Report on Review of Bay Delta Conservation Program Modeling

Since December 2012, MBK Engineers and Dan Steiner (collectively “Reviewers”) have assisted various parties in evaluating the operations modeling that was performed for the Bay Delta Conservation Plan (BDCP). To assist in understanding BDCP and the potential implications, stakeholders¹ requested that the Reviewers review the CalSim II modeling studies performed as part of the BDCP (hereafter “BDCP Studies” or “BDCP Model”).

This Report summarizes: (1) the Reviewers’ independent analysis and review of the BDCP Model, publicly released for the BDCP’s Draft EIR/S in December 2013, (2) the Reviewers’ updates and corrections made to the BDCP Model, and (3) comparisons between the original BDCP Model and the independent Model as revised by the Reviewers.

Figure 23. South Delta Diversion at Banks

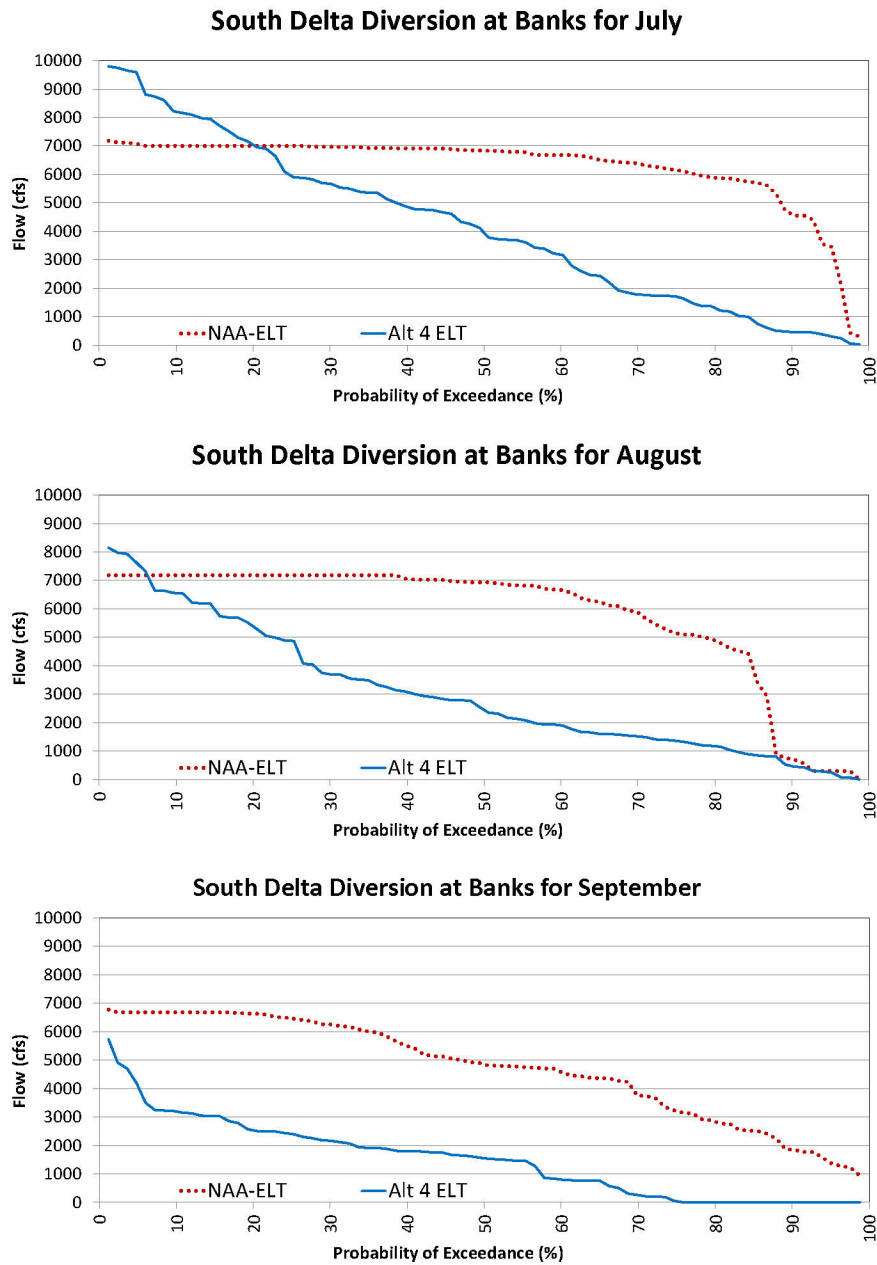
South Delta Diversion at Banks is not limited to existing permit capacity of 6,680 cfs and pumping may reach full capacity of 10,300 cfs in July, August, and September. Figure 23 contains exceedance probability charts of South Delta Diversion at Banks for July, August, and September. The chart for July shows SDD at Banks exceeding existing permit capacity 20% of years, in August this occurs in about 7% of years. There are South Delta diversions at Banks 25% of the time in September while diversions from the Sacramento River may range from 2,500 cfs to 7,500 cfs.

Figure 24. Delta Outflow Change (Alt 4-ELT minus NAA-ELT)

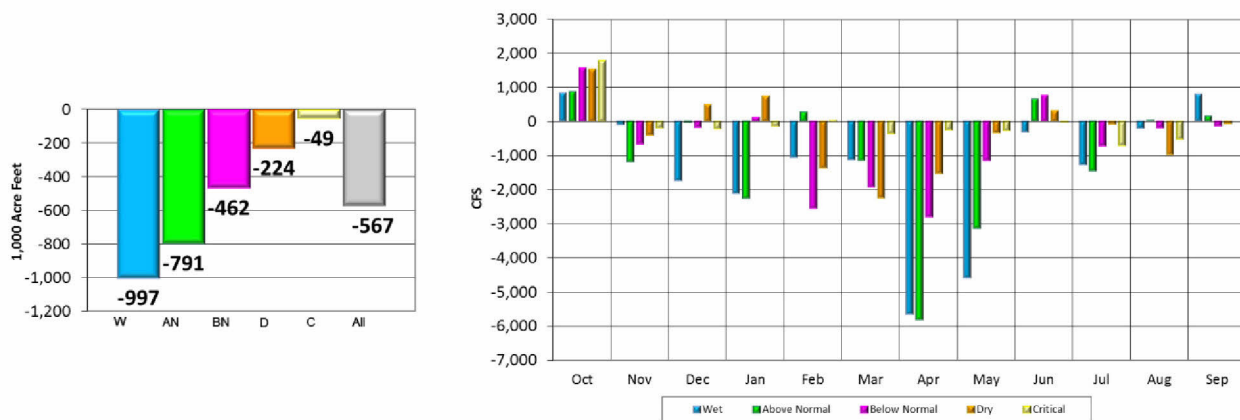
Figure 24 illustrates a comparison of Delta outflow between the NAA-ELT and Alt 4-ELT. Decreases in Delta outflow are the result of the CVP and SWP ability to increase Delta exports in Alt 4-ELT. The apparent increase in Delta outflow in October is partially due to additional export restrictions though Old and Middle River flow requirements. However, the increase in October Delta outflow is also due to an unrealistic operation of the Delta Cross Channel. The additional export restrictions cause the flow standards imposed at Rio Vista to be the controlling point in CVP and SWP operations; the water quality standards are all being met and do not require

flows above the amount needed to satisfy the Rio Vista standard. Meeting the Rio Vista flow standards without closing the Delta Cross Channel gate results in releasing more water from upstream reservoirs than would otherwise be necessary. This occurs because a certain amount of the water released to meet the Rio Vista flow standards would flow into the Central Delta at location of the Delta Cross Channel gate. This water would not make it to Rio Vista and therefore would not be counted towards meeting the Rio Vista flow standards. However, due to the BDCP model’s assumed restrictions on exports at this time, this water could not be pumped from the South Delta facilities and thus ends up as “extra” Delta outflow. By closing the Delta Cross Channel gate, the operators would assure that all of the water released to meet the Rio Vista flow standards would be counted towards those standards. The BDCP model’s assumptions that the Delta Cross Channel gate would not be closed are not practical or a sensible operation as the operators confirmed they would close the gate during these conditions to avoid the unnecessary loss of water supplies (as was done in October and November 2013). The assumption in the BDCP model to maintain the gate in the open position causes it to overstate the amount of Delta outflow.

Figure 60. NDD, and Sacramento River Flow

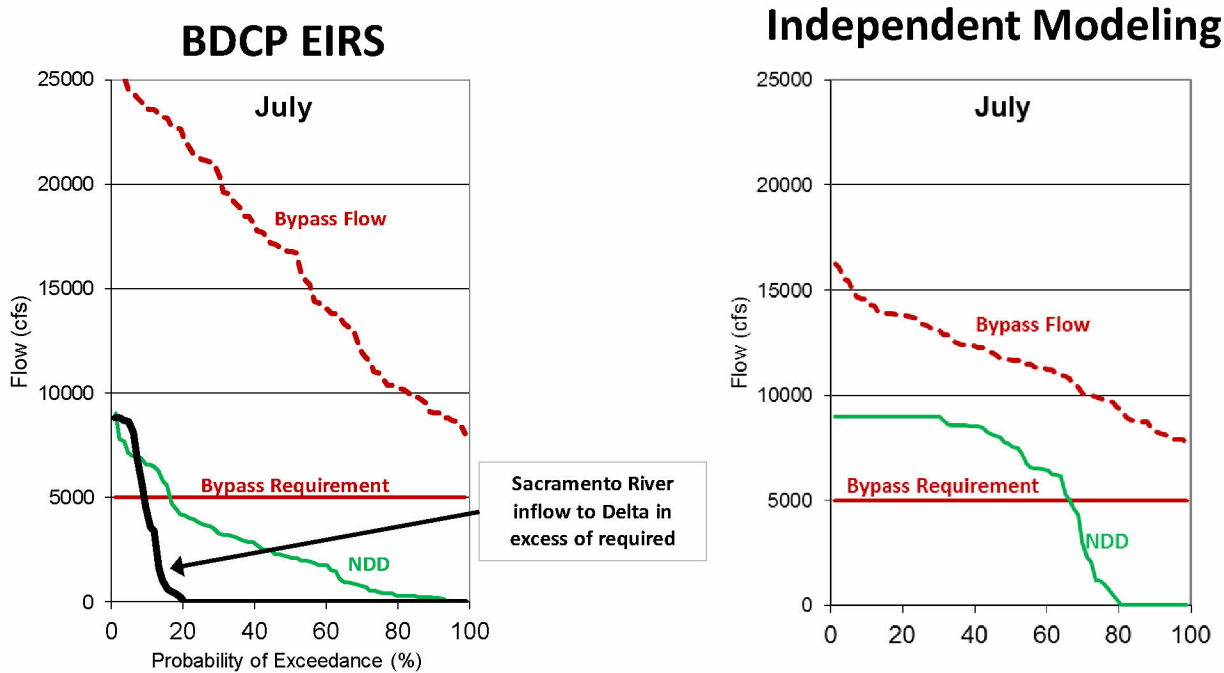
Independent modeling shows greater NDD during July and other months because the BDCP EIRS modeling includes artificially high Sacramento River bypass flow requirements. Figure 60 contains exceedance probability plots of Sacramento River required bypass, Sacramento River bypass flow, NDD, and excess Sacramento River flow to the Delta. As can be seen in Figure 60, bypass flow is always above the bypass requirement. The BDCP version of CalSim sets a requirement for Sacramento River inflow to the Delta that the independent modeling does not need in order to satisfy Delta requirements, therefore the NDD is higher in the independent modeling.
